## Service Bulletin #009-01-2003

**relating:** FK9 Mk 3 / MkIV  
**serial numbers:** #089 - #215  
**subject:** optimization of parachute exit area  
**limits:** according LTA (german light aircraft authorithys)

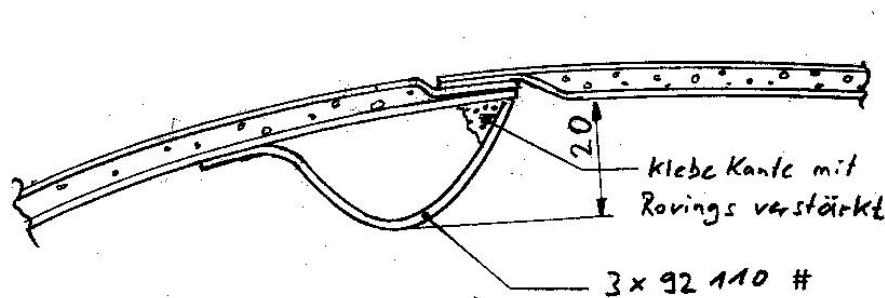
A preformed fiberglass part will be glued inside the fuselage aruond the exit-door opening for parachute in such way, that no sharp corners can cause parachute dammages when parachute exits fuselage.

Eine großzügige Ausrundung soll ein Verhaken von Fallschirm oder Gurten an der der Gleitkante selbst verhindern.

The part has to be installed according installation procedure.

Planes without exit door are required to install actual serial parachute exit door.
